Federal Aviation Administration

Memorandum

Subject: Equivalent Level of Safety to § 23.1397(c); Cessna Aircraft Company, Models 172R, 172S; Finding No. ACE-07-10

FIGURE 1

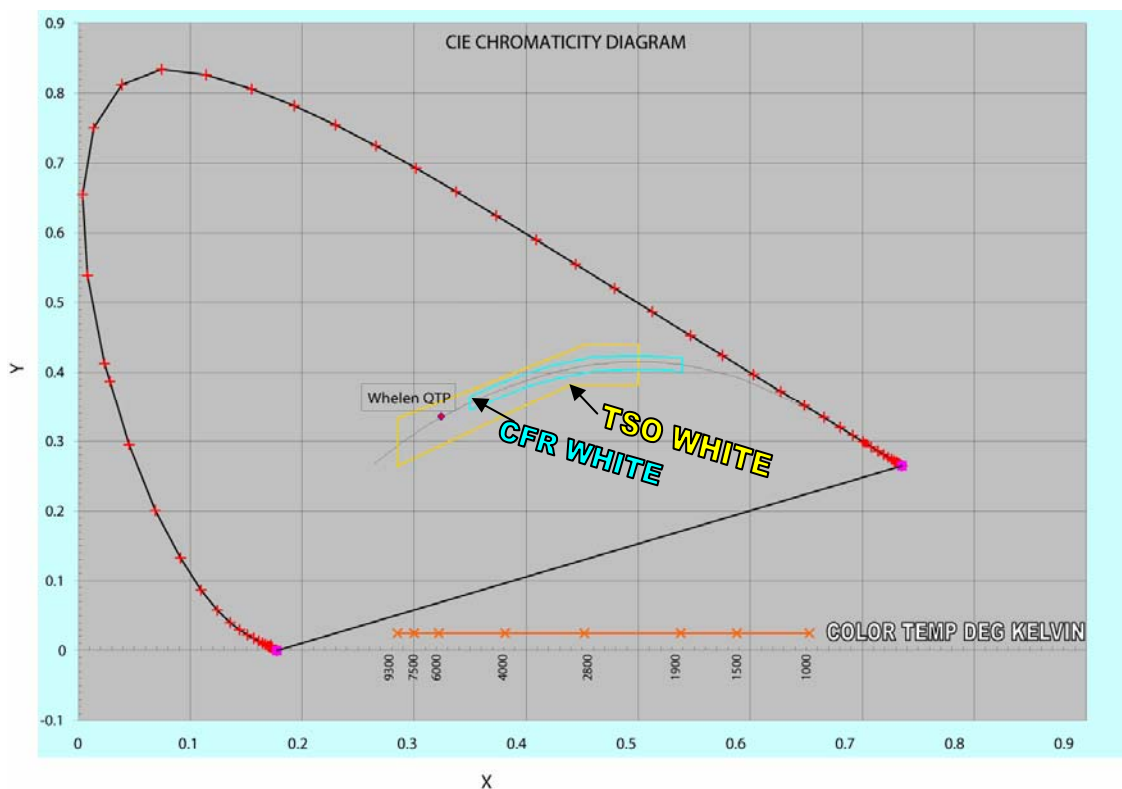
The diagram (Figure 1) shows the boundary of the 14 CFR part 23, § 23.1397 (c), Amendment 23-N/C requirements and the boundary permitted by TSO-C30c. The TSO boundary, dictated by the AS8037 requirements has a significant overlap with the 14 CFR part 23, § 23.1397 (c), Amendment 23-N/C requirements, however, there are portions of the two requirements that do not overlap. Since the requirement to produce the lights is defined by AS8037, Cessna believes that while some light assemblies might meet the requirements of 14 CFR part 23, § 23.1397(c), per Amdt. 23-N/C, others might only meet the requirements dictated by the TSO which would result in non-compliance.

These diodes exhibit very little color shift over long periods of time. Chromaticity measurements by the LED manufacturer and the light supplier at 0 and 13,200 hours of operation show the color shifting towards yellow-green (less than .01 for the x or 0.015 for the y coordinates) but remaining within the TSO-C30c color boundaries for white. Furthermore these LED(s) tested were operated with higher junction temperatures than would typically be experienced on the aircraft models listed above. The color shift trend shows that the chromaticity is expected to remain within the TSO-C30c white limits throughout the life of the aircraft with an imperceptible color shift after initial burn in. Furthermore, as this LED system reaches its end of life, the color shift occurs towards the yellow green direction of the CIE color chromaticity coordinates system and still remains within the TSO C30c white which the FAA has recognized within TSO-30c itself as providing an equivalent level of safety. Hence, a pilot would not misinterpret it as a red or green color. Cessna submits that the color white as defined by TSO-C30c meets the intent of 14 CFR part 23, §23.1397(c), Amendment 23-N/C and therefore, an ELOS is justified.

The chromaticity requirements are intended to provide, within limits, a standardized perception of “white” to the human eye. The FAA considers that excursion from the 14 CFR part 23, § 23.1397 (c) Amendment 23-N/C requirements for the LED color white, while remaining within the requirements provided by TSO-30c for the color white, provides a light that results in an equivalent level of safety to that required by the regulation. This determination is applicable for the part number listed above and derivative parts from the same manufacturer whose chromaticity is exactly the same as the one discussed here and used on the Cessna Models 172R and 172S. The ACO concurs that the current Cessna Models 172R and 172S rear position light configuration has been analyzed and provides an equivalent level safety for § 23.1397(c) amendment N/C.
